FINAL DRAINAGE REPORT FOR CLAREMONT BUSINESS PARK 2 FILING NO. 2 EL PASO COUNTY, COLORADO

February 2023

Project #10-020
PCD Filing No.: VR233 k

EXISTING DRAINAGE MAP

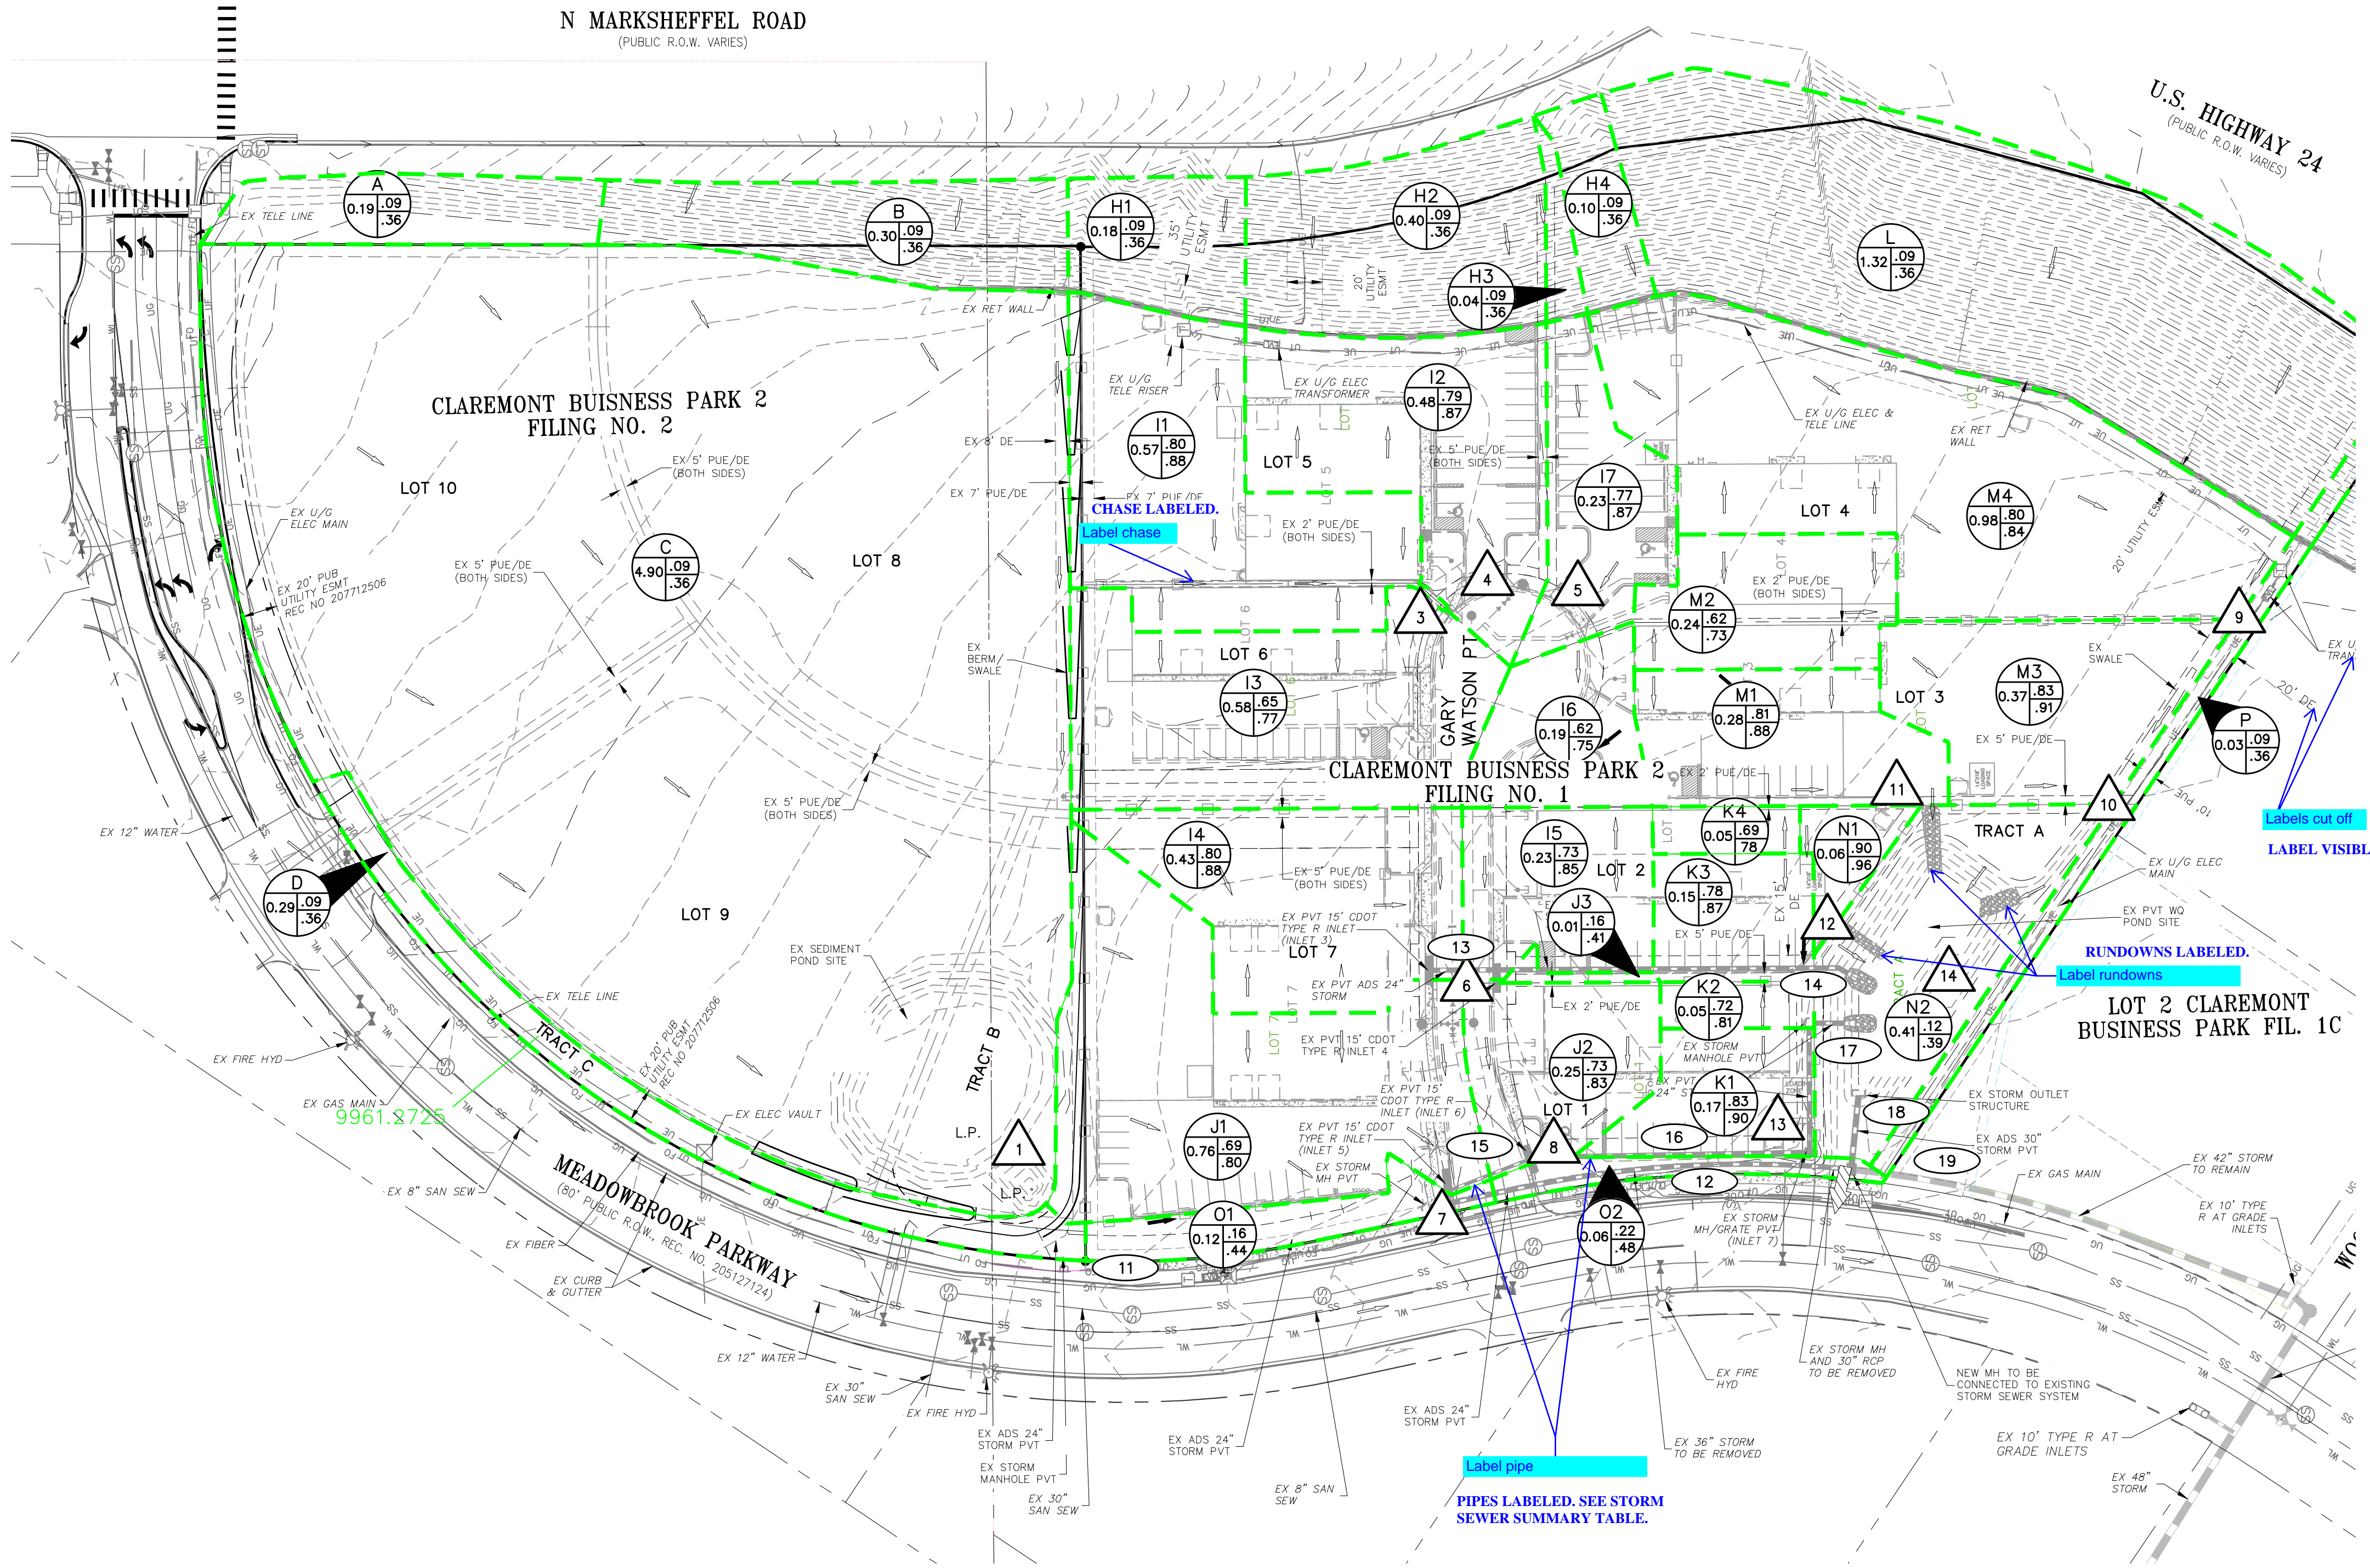
Add Contour Labels
MAJOR CONTOURS LABELED.

Labels cut off
LABEL VISIBLE.

RUNDOWNS LABELED.
Label rundowns

Label chase

Label pipe
PIPES LABELED. SEE STORM SEWER SUMMARY TABLE.

H4
BASIN LABEL REVISED.

**CLAREMONT BUSINESS PARK 2 FIL. NO.2
PROP. CONDITIONS DRAINAGE MAP**

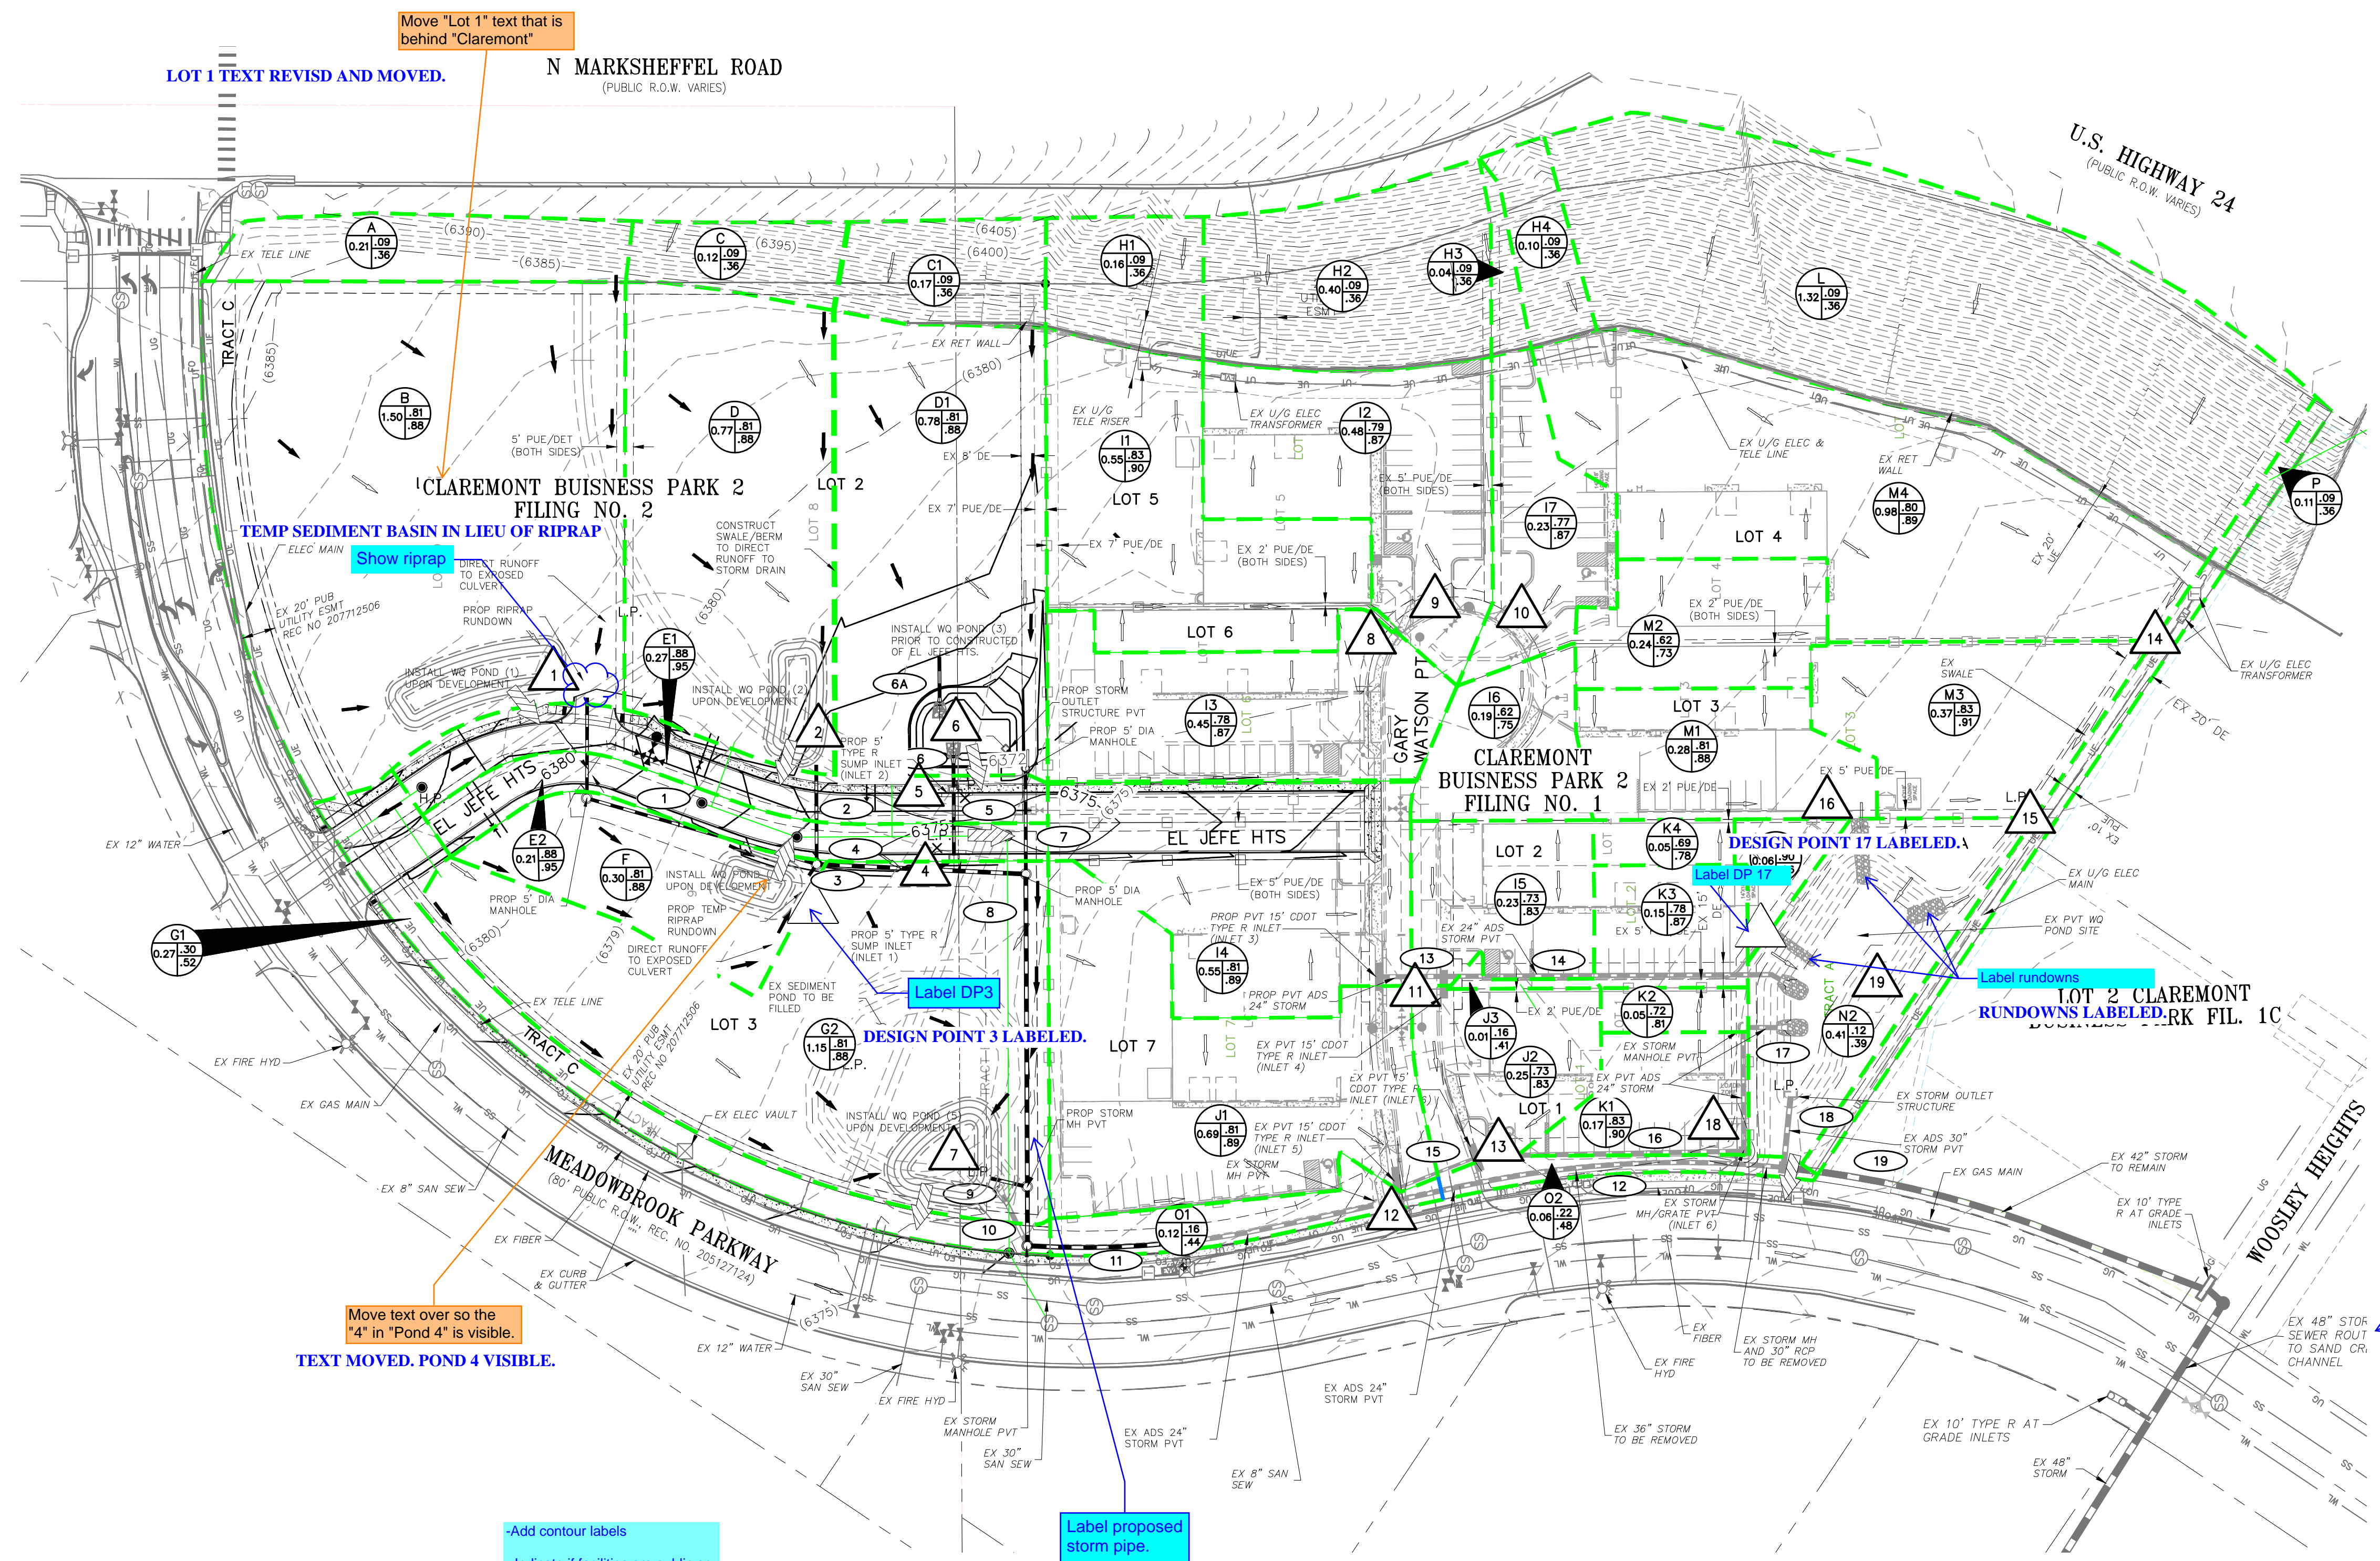
Move "Lot 1" text that is behind "Claremont"

Show riprap

-Add contour labels

PROPOSED AND EXISTING CONTOUR LABELS ADDED. FACILITIES LABEL PRIVATE.
